Work Order ID 164434

D3016-041 SEAT FRAME ASSEMBLY

DRAWING NO. D3016	TITLE SEAT FRAME ASSEMBLY	REV. A	DART AEROSPACE LTD ENGINEERING ORDER	D.E.O. NO. D3016-A-1	SHEET NO. SHEET 1 OF 1	SCALE NTS
DRAWN <i>1</i>	CHECKED <i>UP</i>	MFG. APPR. <i>R</i>	APPROVED <i>W</i>	DE APPR. <i>W</i>		
DATE 10.01.29	DATE 10.01.29	DATE 10.01.29	DATE 10.01.29	DATE 10.01.29	DATE 10.01.29

TO REVISE D3016-11 SADDLE'S HOLE SIZES

D3016-11 SADDLE

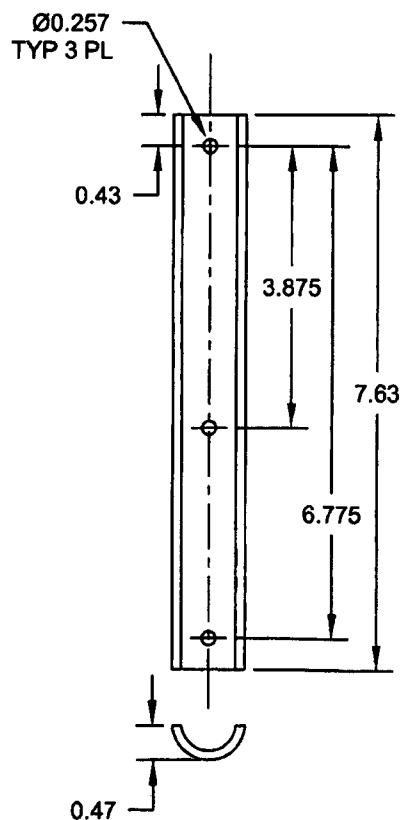
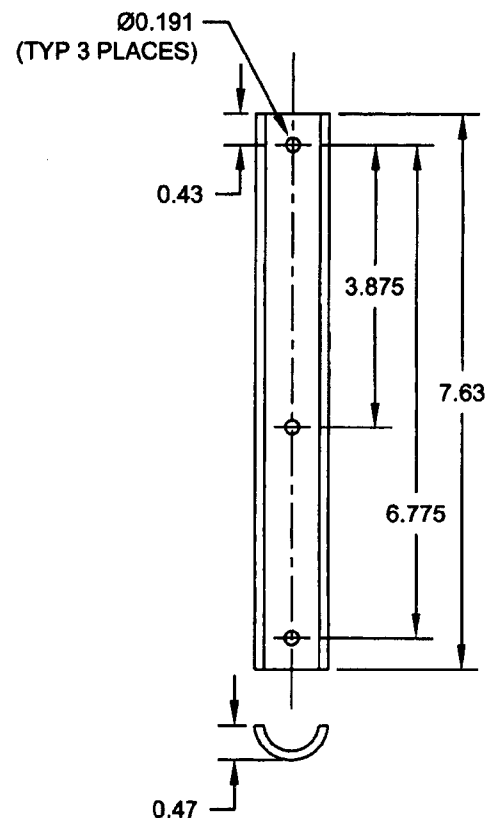
DETAIL D3016-11 SADDLE (SHEET 3): Ø0.257 TYP 3 PL WAS Ø0.191 (TYP 3 PLACES) AS SHOWN:
